# HISTORIC AND DESIGN REVIEW COMMISSION

**HDRC CASE NO:** 2023-261  
**ADDRESS:** 1210 E ELMIRA ST  
**LEGAL DESCRIPTION:** NCB 6796 BLK 8 LOT 1 THRU 3 & S IRR 124.65 OF 4-6 & S IRR 42.09 FT OF 7  
**ZONING:** IDZ, RIO-2  
**CITY COUNCIL DIST.:** 1  
**APPLICANT:** Michael Elder/Oxbow Real Estate, LLC  
**OWNER:** Michael Elder/Oxbow Real Estate, LLC  
**TYPE OF WORK:** Construction of an 8-story hotel  
**APPLICATION RECEIVED:** June 30, 2023  
**60-DAY REVIEW:** August 29, 2023  
**CASE MANAGER:** Edward Hall  
**REQUEST:**

The applicant is requesting conceptual approval to construct an eight-story hotel structure on the lot addressed as 1210 E Elmira. This lot is bounded by Schiller Street to the south, E Elmira Street to the west, Myrtle Street to the north and the San Antonio River to the east. This lot is located within the River Improvement Overlay, District 2.

### WINTER SOLSTICE

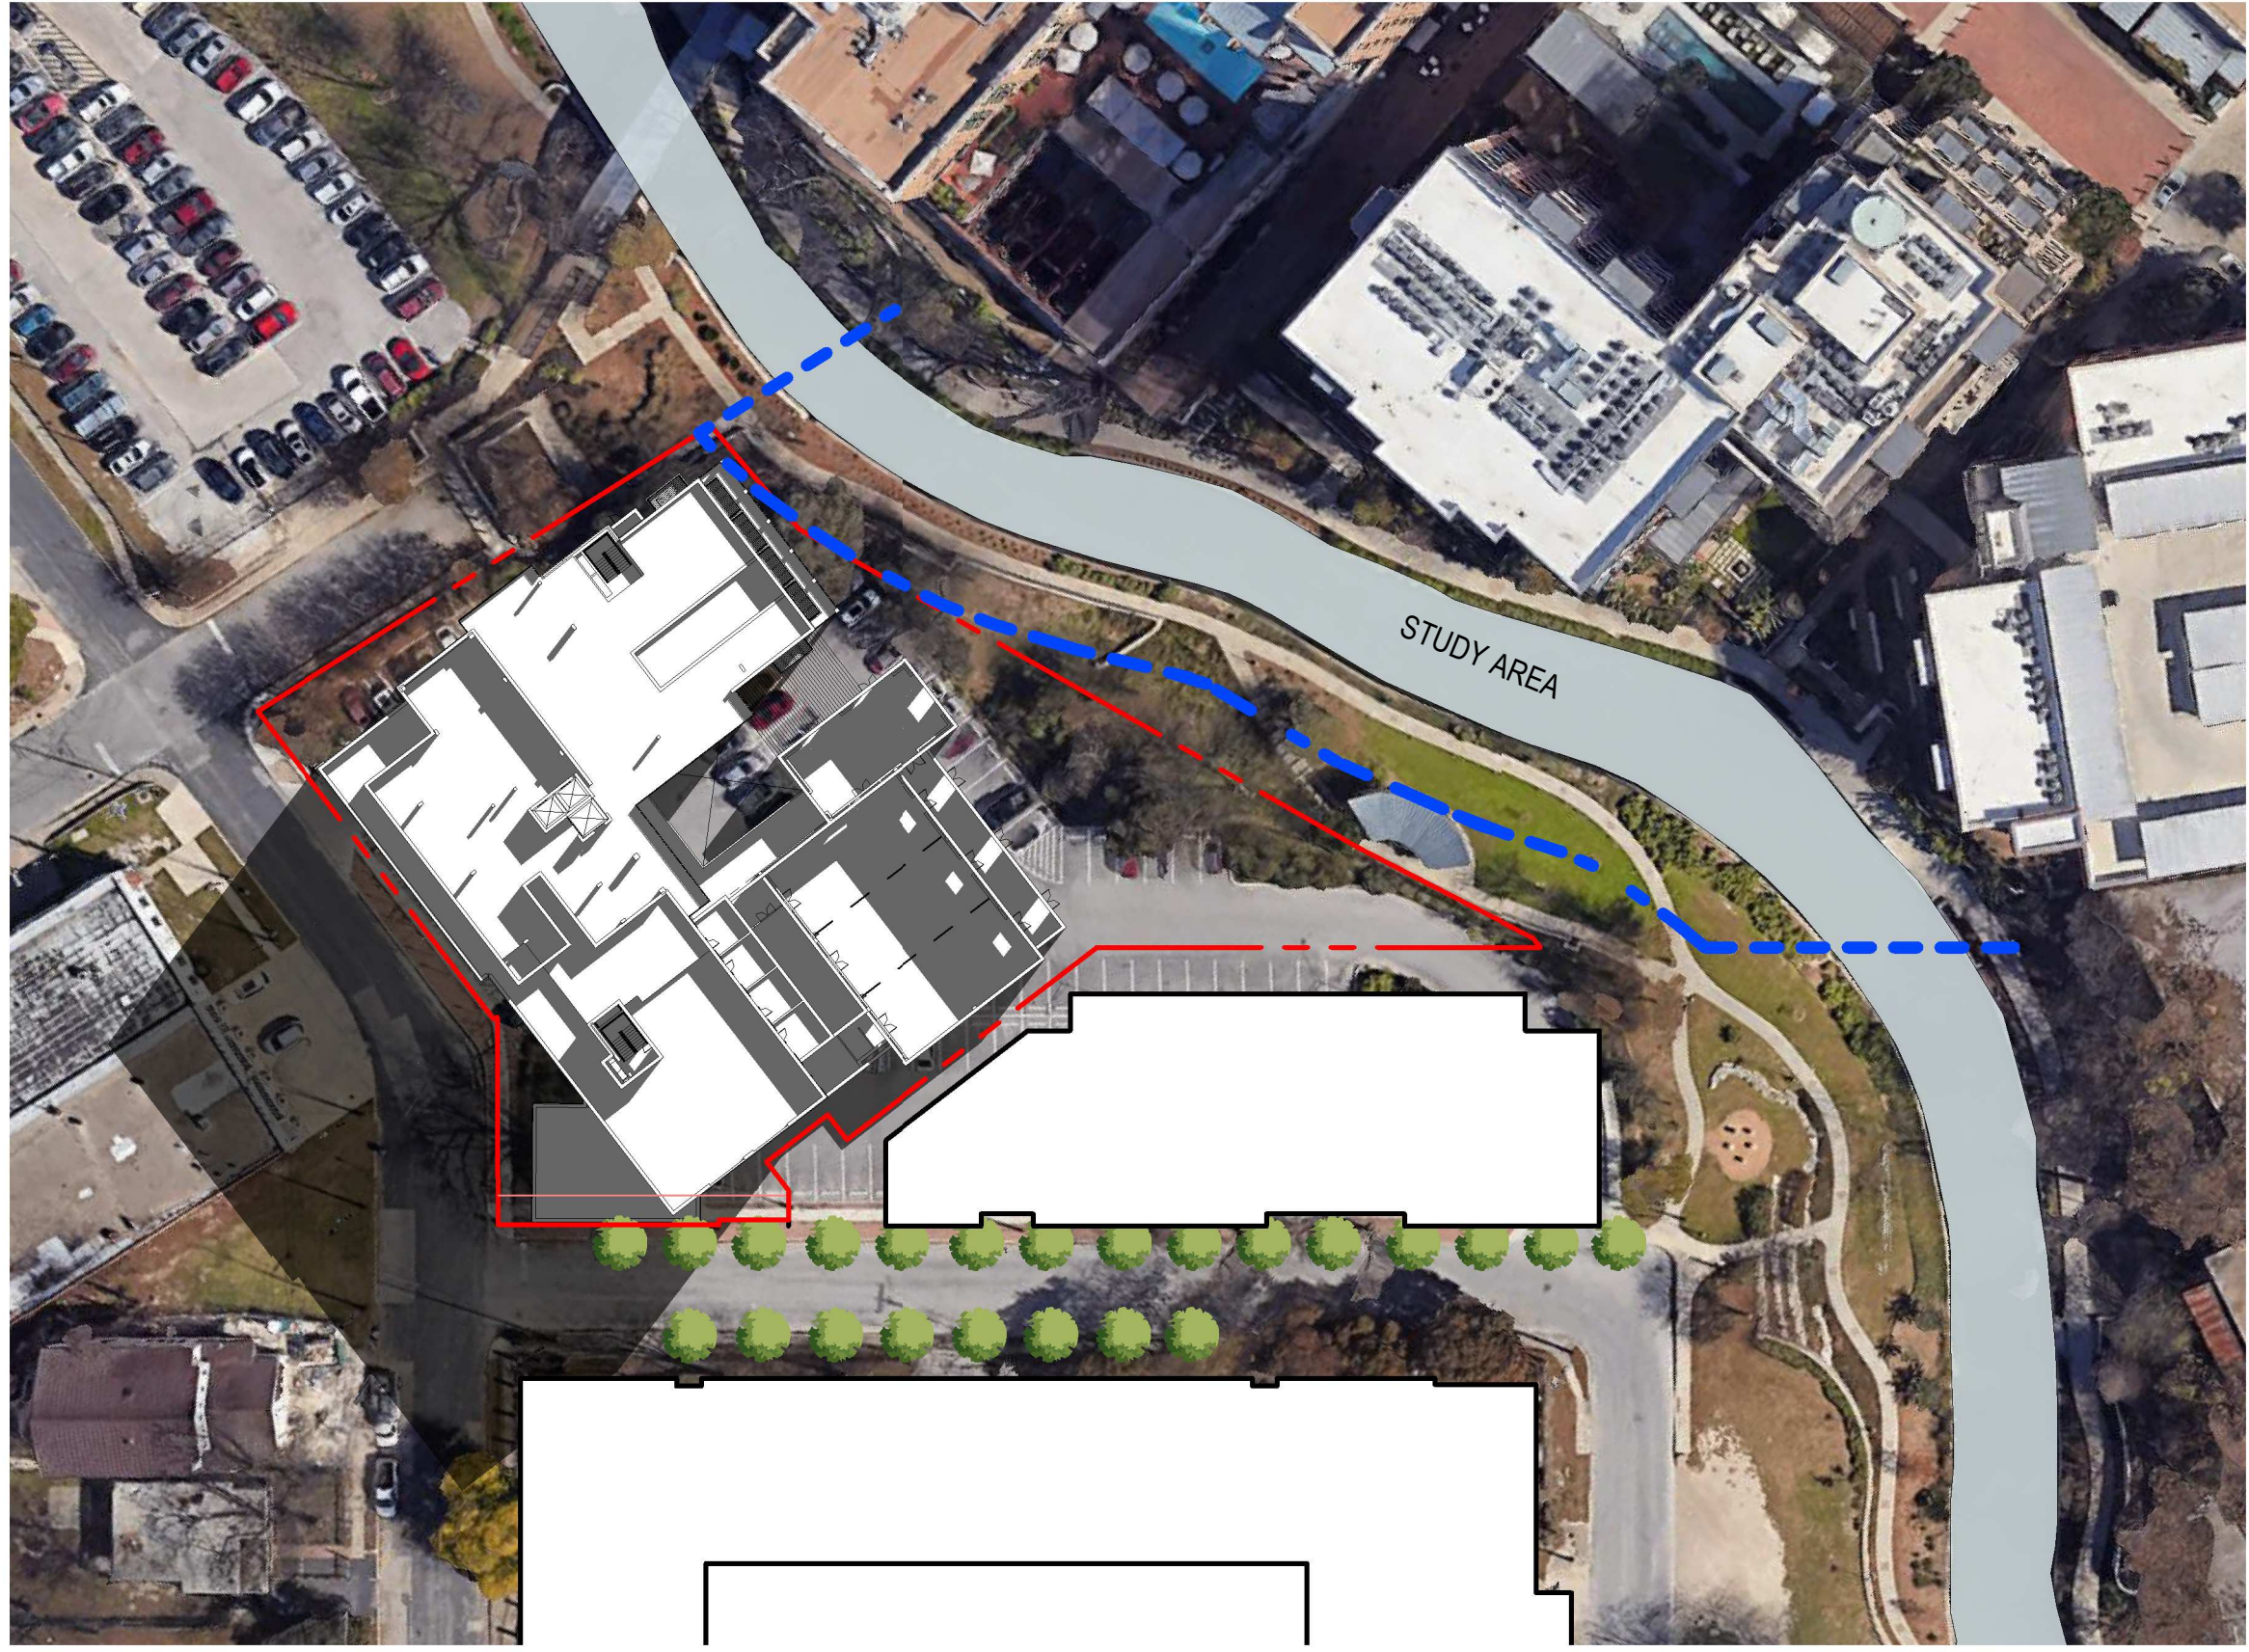
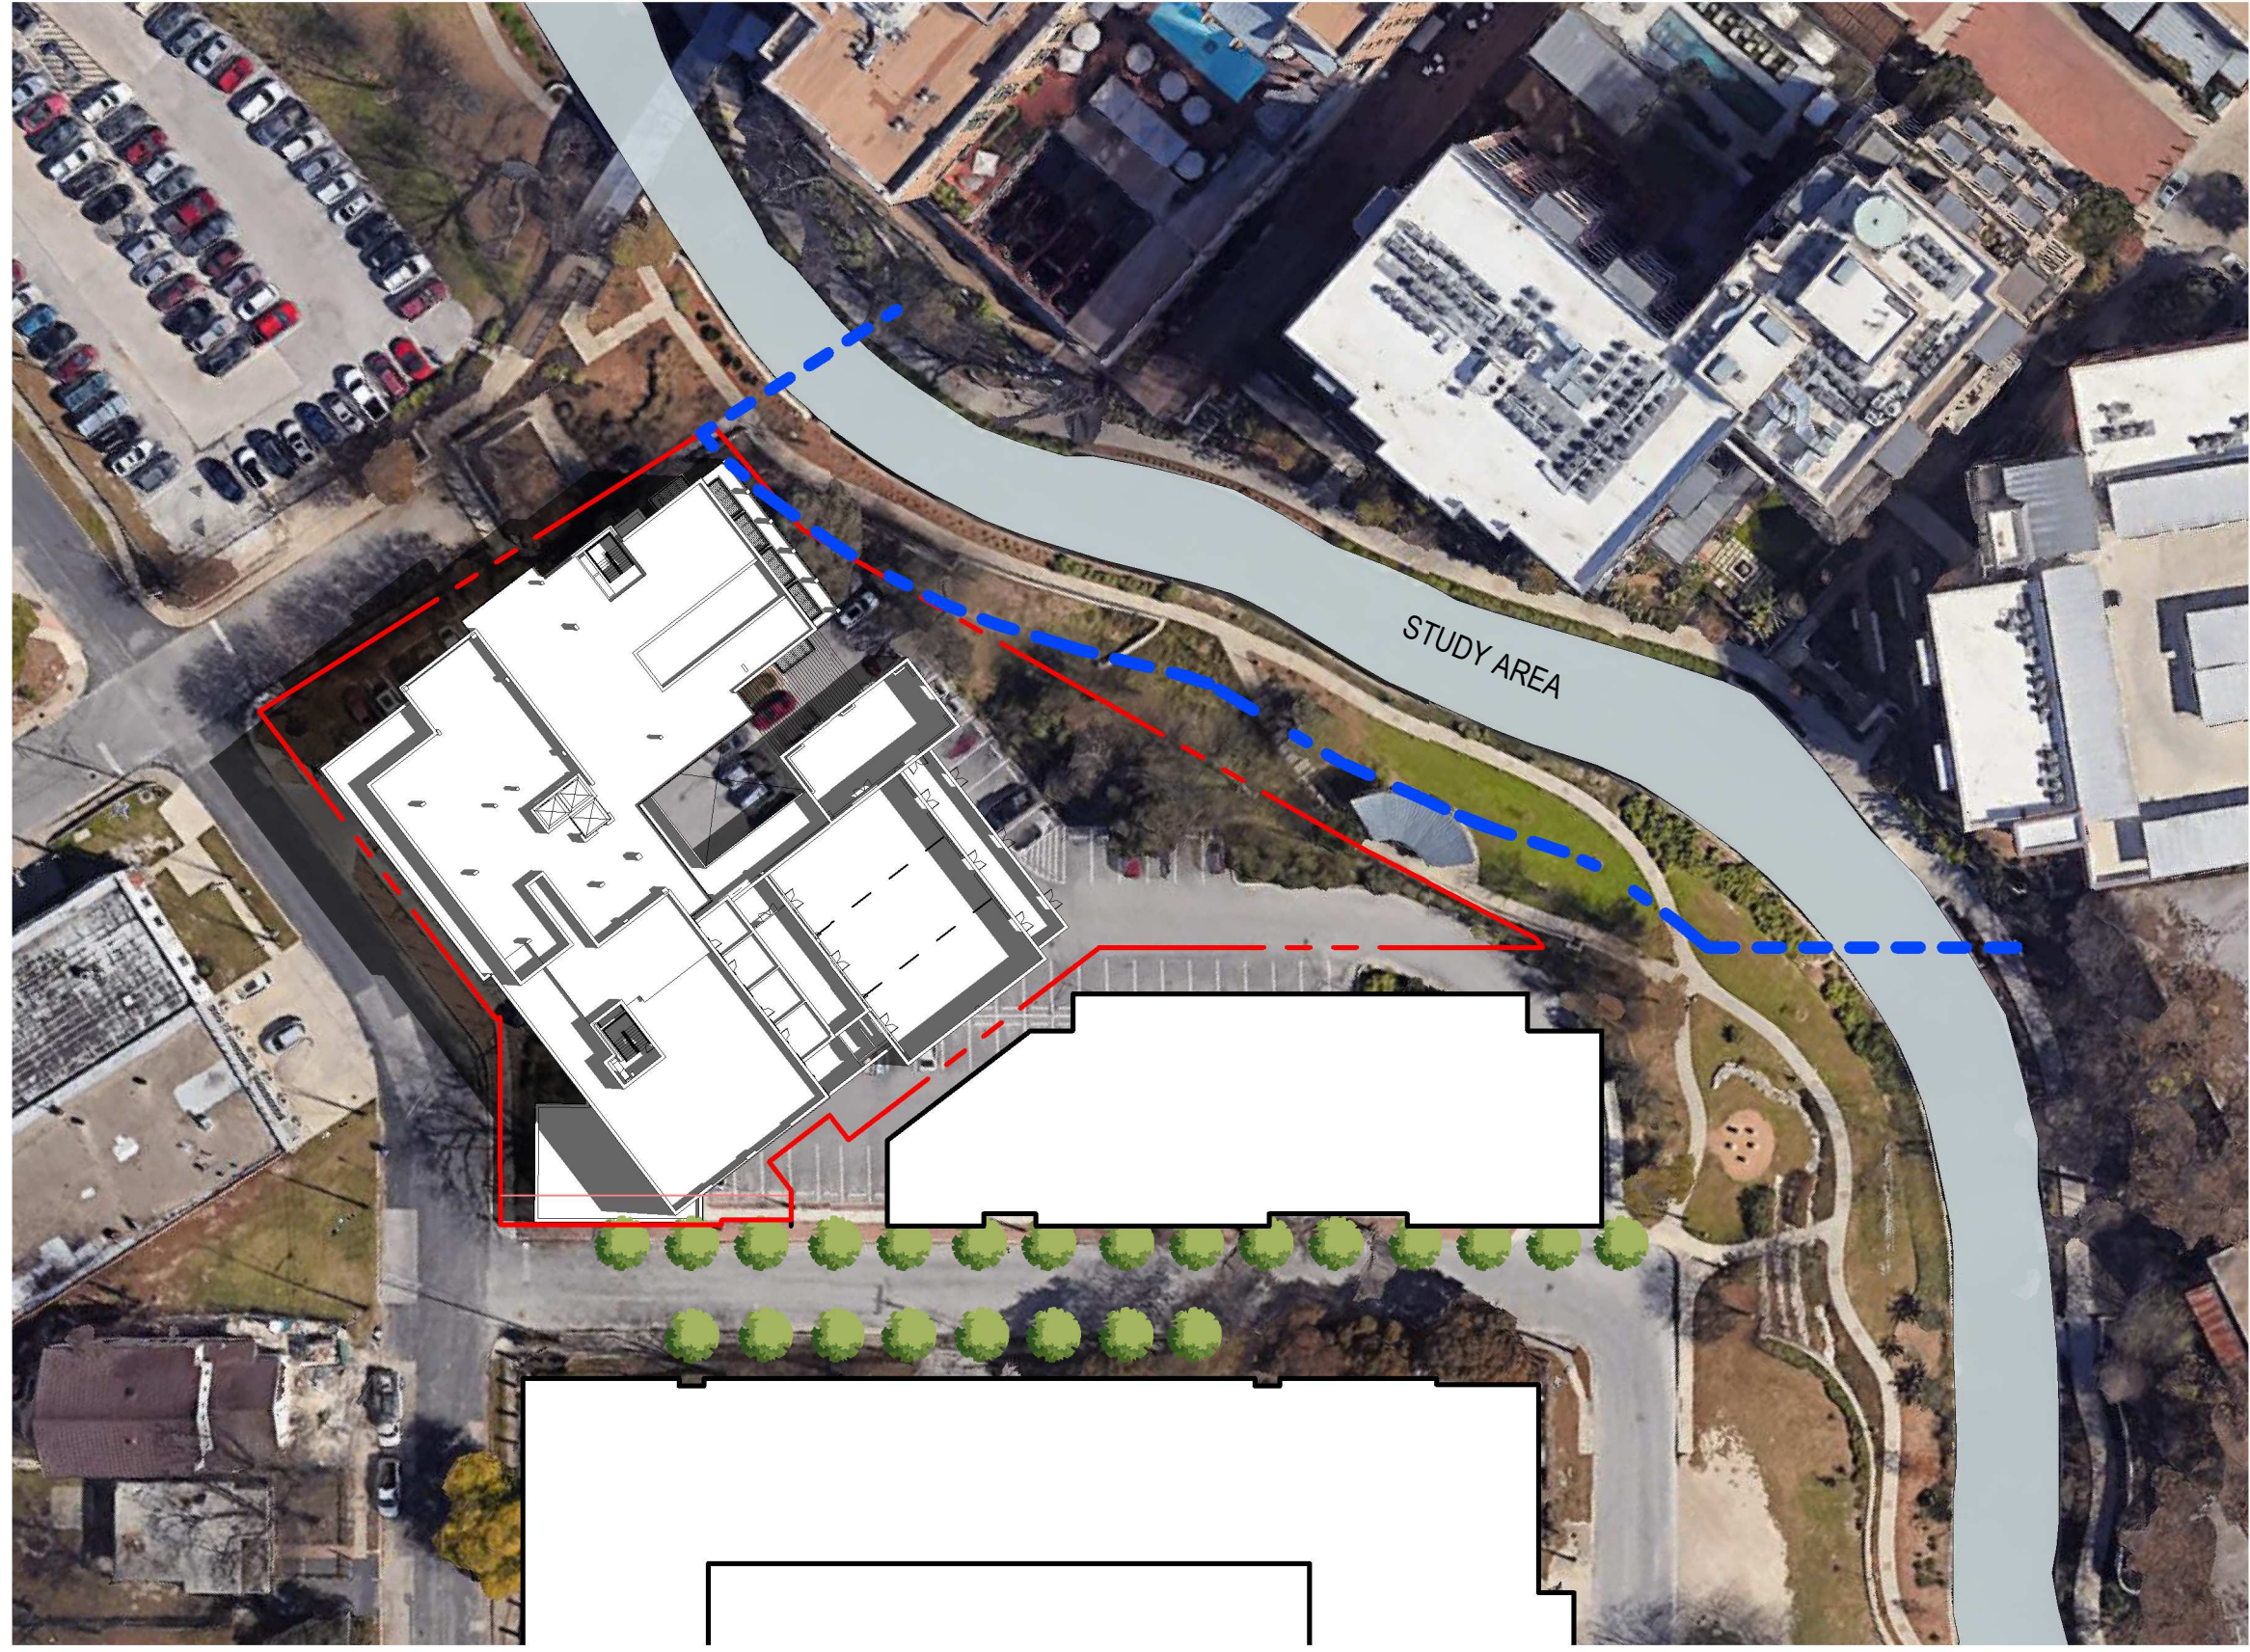
FULL SOLAR ACCESS FROM 7:24 AM (SUNRISE) TO 1:00 PM

RECEIVES 5.5 HOURS OF SUNLIGHT; MEETS 5.5 HR RQMT
